## **APPLICATION FOR URBAN DESIGN COMMISSION**

Northport Commons, 542 Northport Drive

RE: Minor alteration to SIP at 4210-4216 Kennedy Road

4 UNIT TOWNHOUSE 4210-4216 KENNED MADISON WI

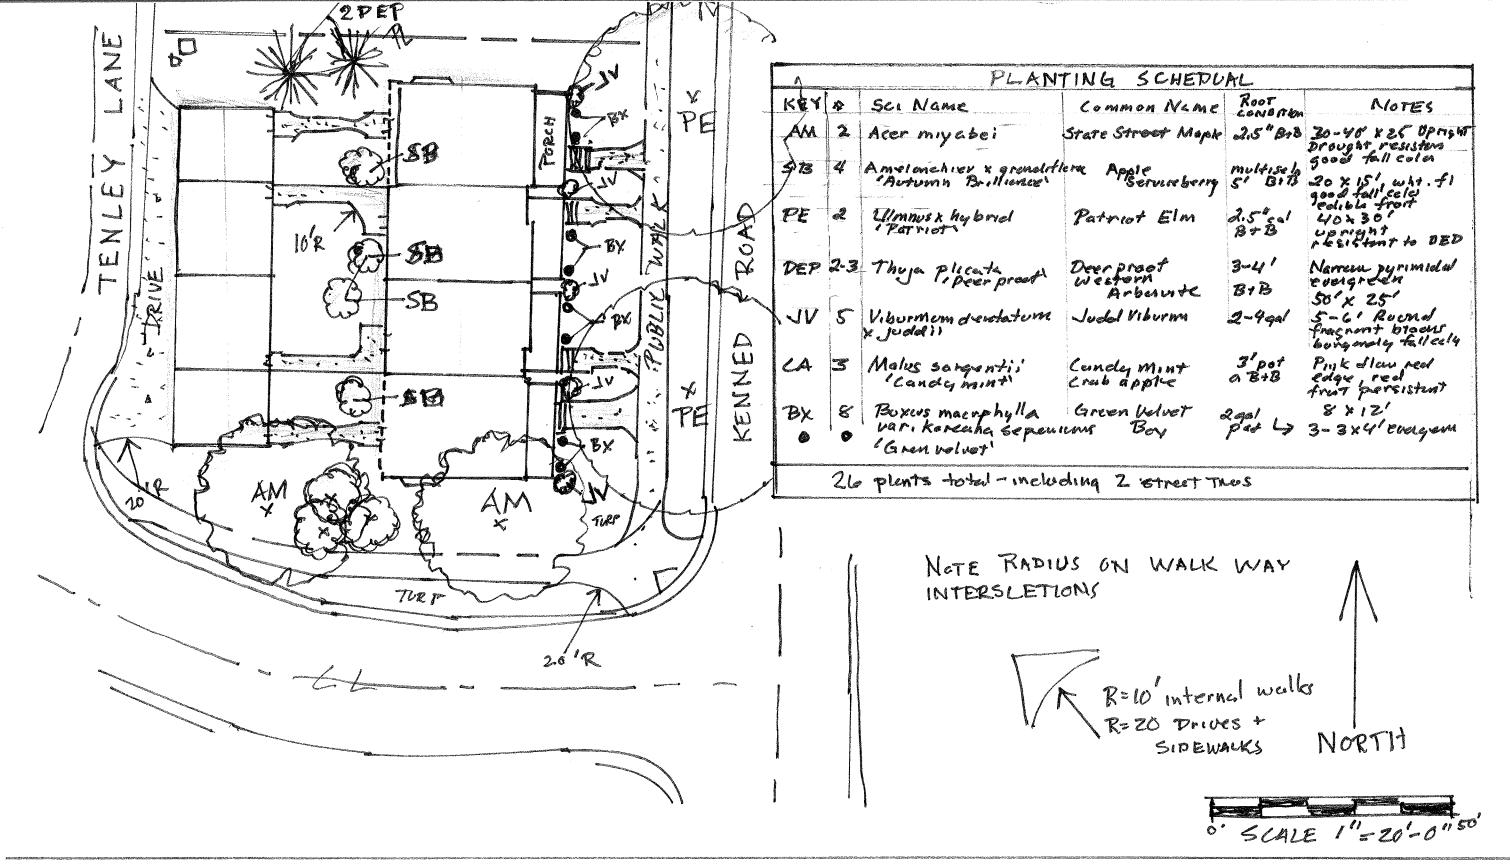
Habitat for Humanity of Dane County requests permission to alter the SIP for the 4-unit bank of townhouses it's currently building at 4210-4216 Kennedy Road, in the Northport Commons subdivision. Specifically, we request permission to make the following changes:

- Alter the rooflines of the units, as represented by the plans: Our changes involve a simplification to the rooflines, typically by extending the total span of the gable roof in order to eliminate some of the intersecting gabling and their associated valley assemblies intended by the original plan. Such a simplification will pose a less challenging roof assembly to our groups of volunteers who will be doing the work, especially given its location two stories above ground level. We believe that the requested changes will yield a more volunteer-friendly roof, while still preserving the essential character, demeanor, and appearance of the original plan.

- Simplify the exterior detailing in exchange for better fenestration: Exterior features such as false shutters and 'gingerbread' gabling ornamentation may enhance curb appeal, but here the massing of the building along the street is sufficiently differentiated to yield an interesting façade; and given the strict construction budgets demanded by our building program, we work to stretch every building dollar for the well-being of our families. We believe, therefore, that the additional windows suggested for the side and rear elevations both yield a better interior for our families and strengthen the exterior elevations.
